**ADDENDUM NO. 1
July 25, 2022**

**2022 Midfield Ramp Repair – Phase 1
Duluth International Airport (DLH)
Duluth, Minnesota
City of Duluth No. 22-4402
SEH No. DULAI 161944**

**Taxiway A Reconstruction – Phases 2 & 4
Duluth International Airport
Duluth, Minnesota
AIP No. 3-27-0024-074-2022
SP No. A6901-205
SEH No. DULAI 165102 & 167744**

JOINTING PLAN - PHASE 4

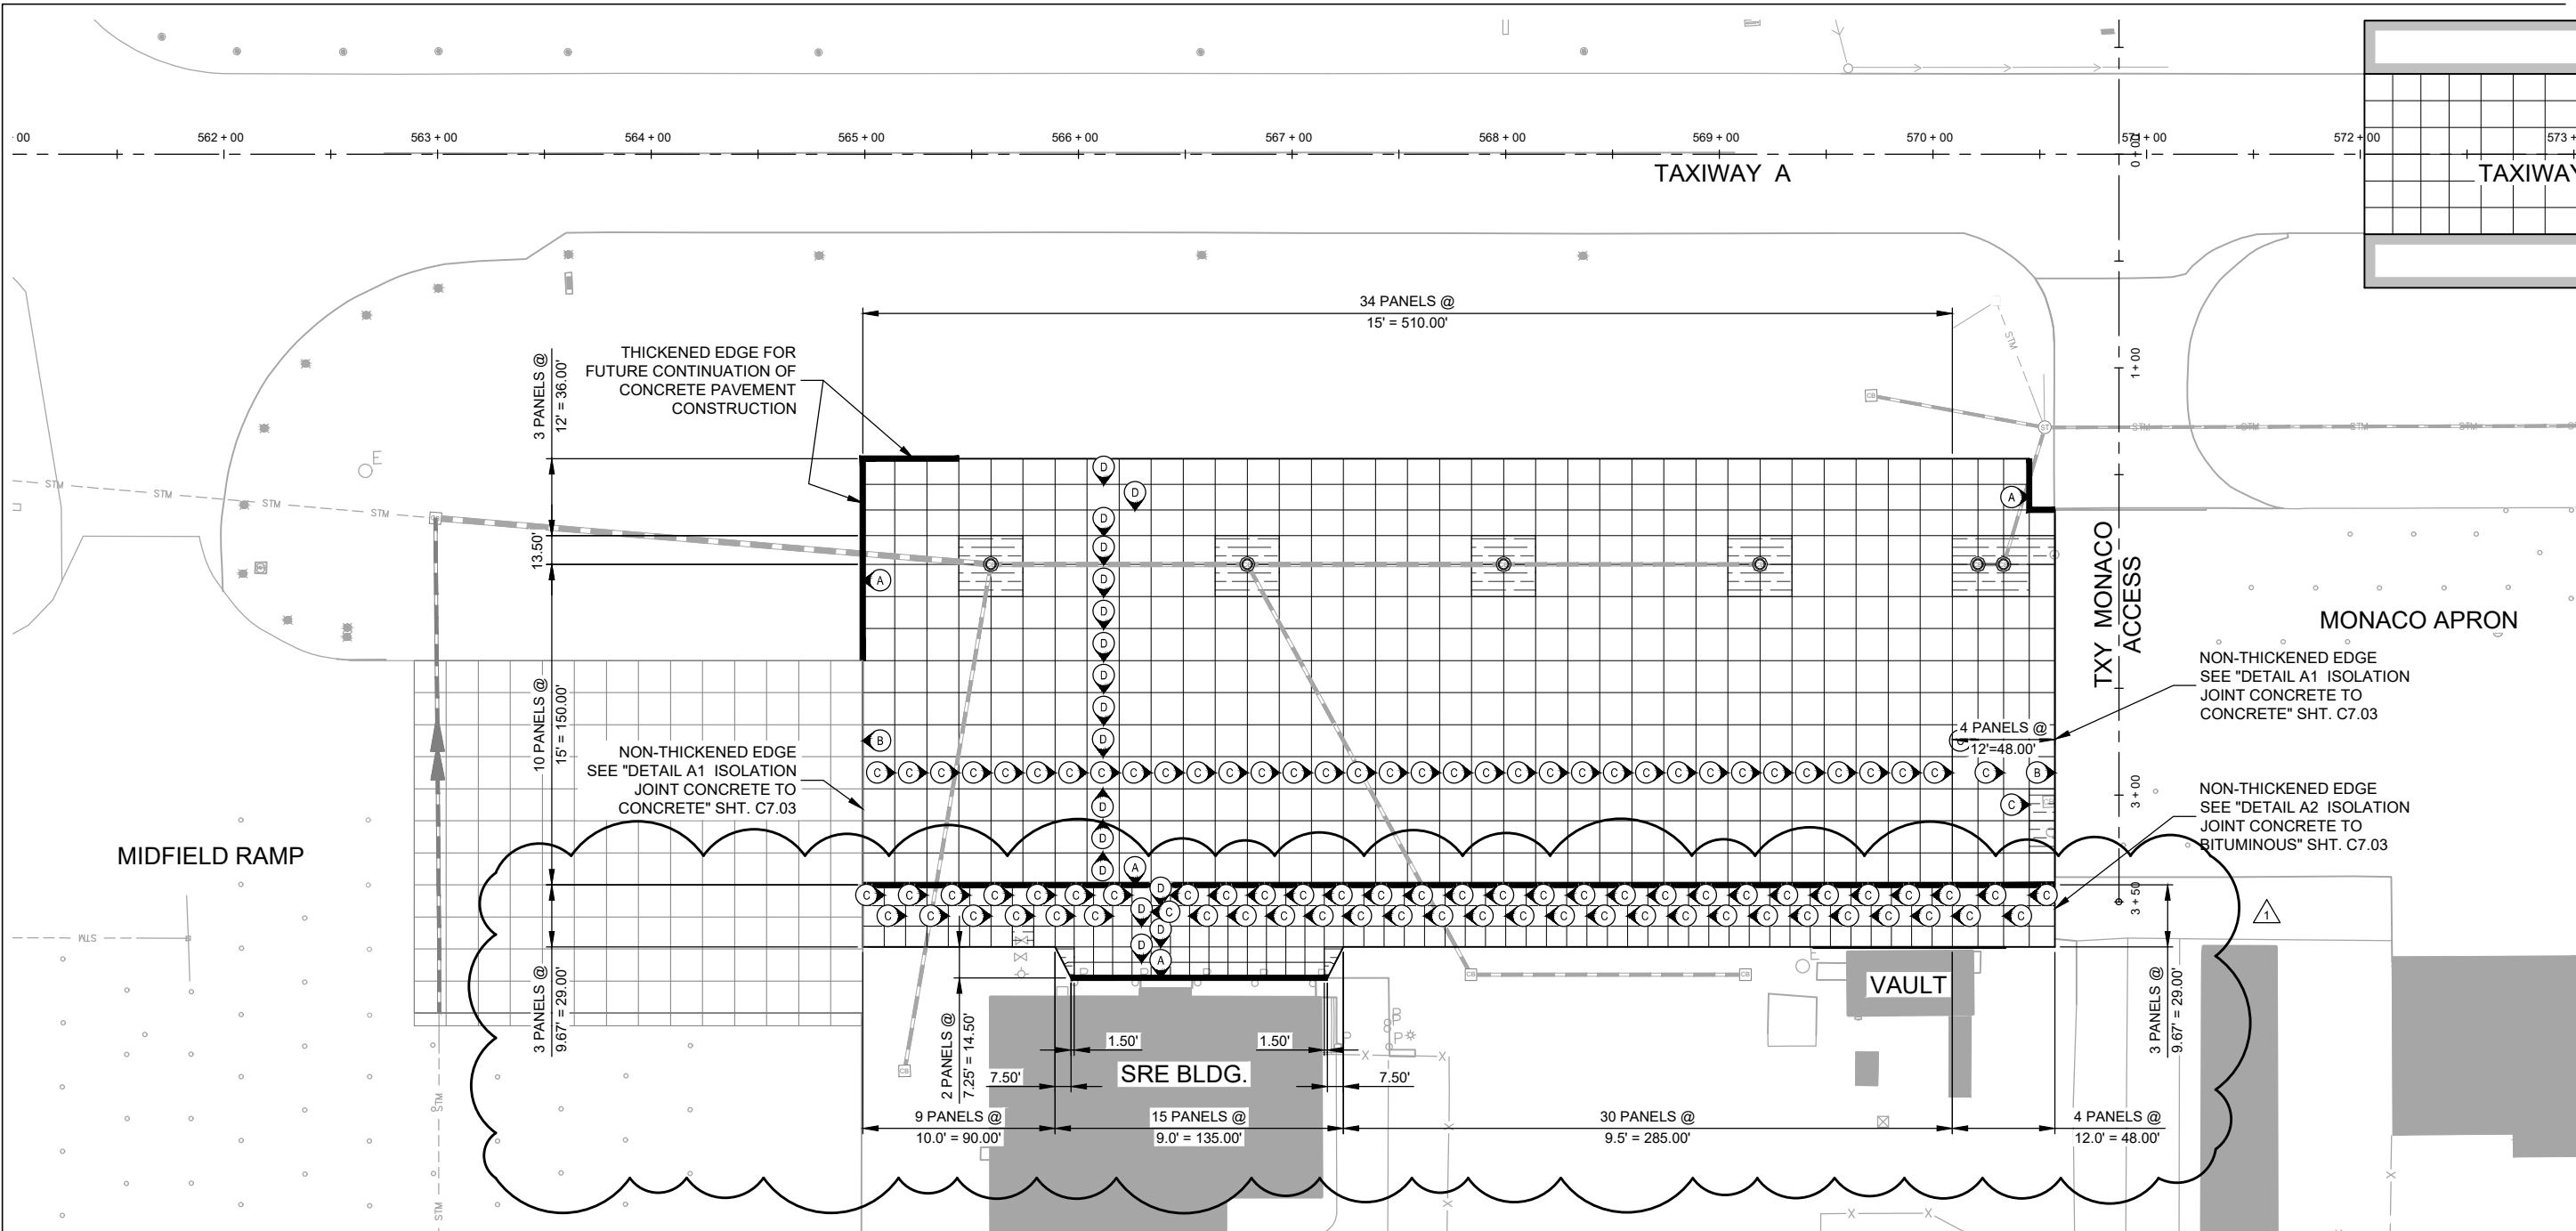
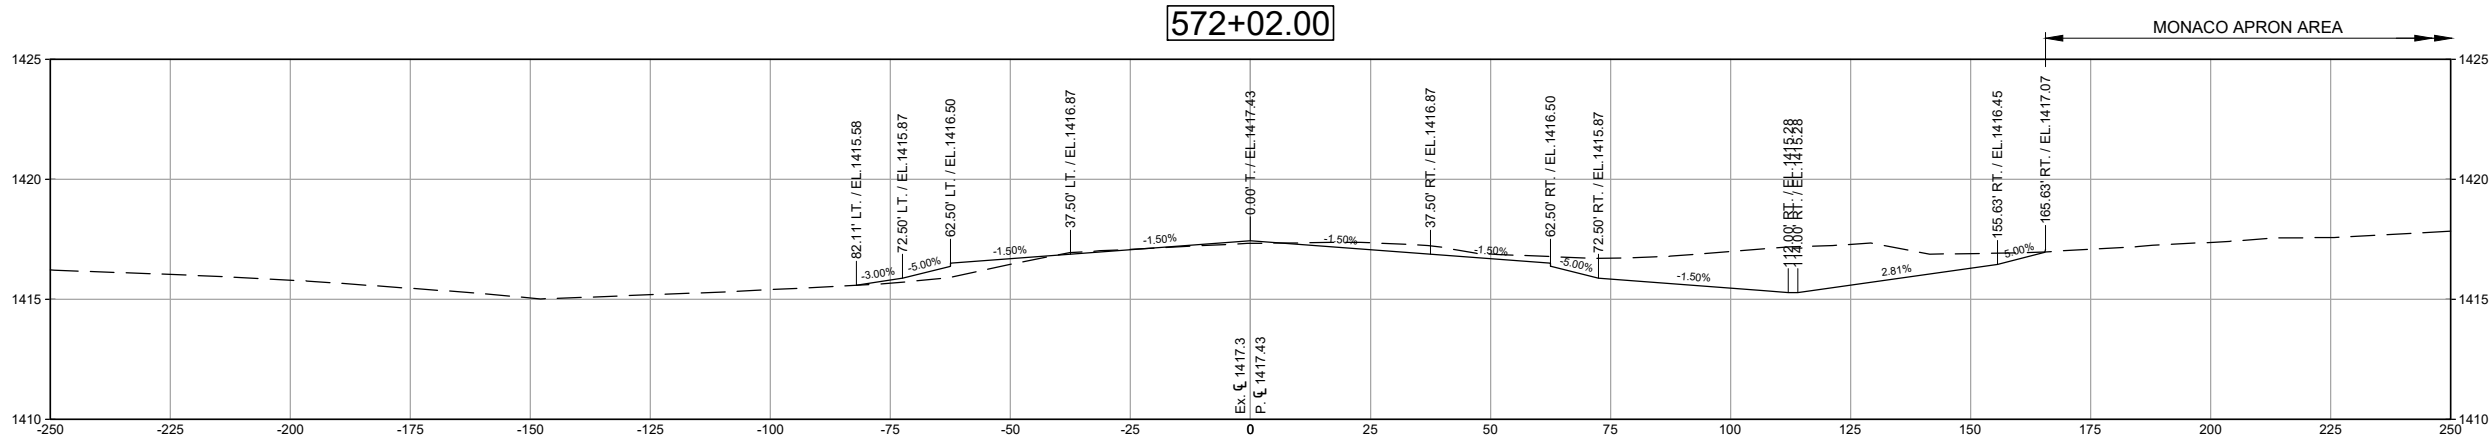
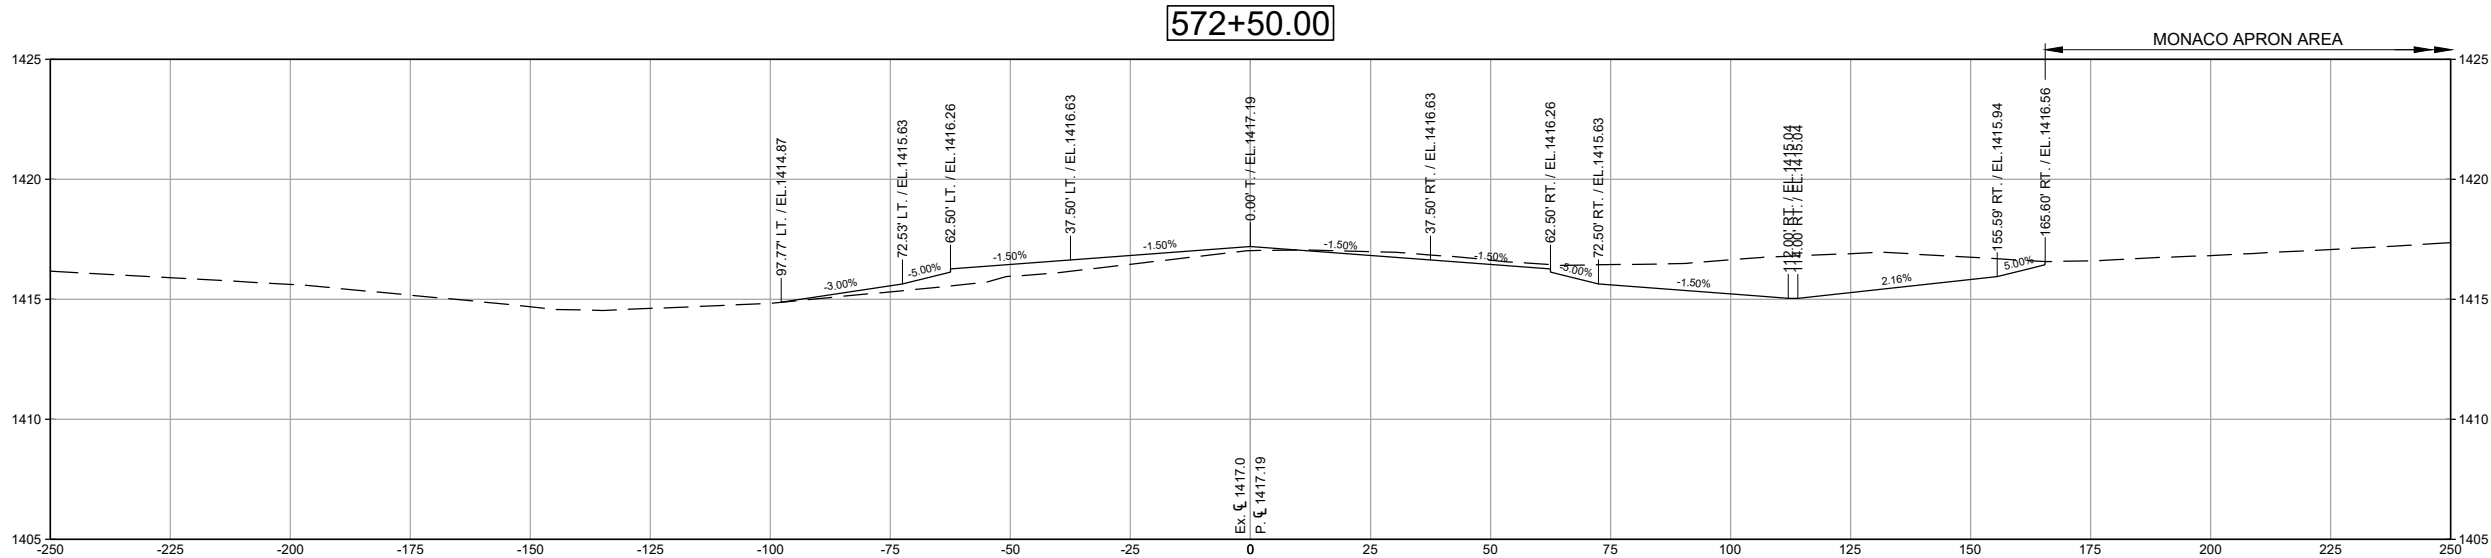
21. Drawing C5.11 Storm Sewer Details - Pipe Trench Detail updated to Class B Trench.
22. Drawing C7.02 Jointing Plan – Phase 4 - The jointing plan for the SRE Apron VSR has changed.
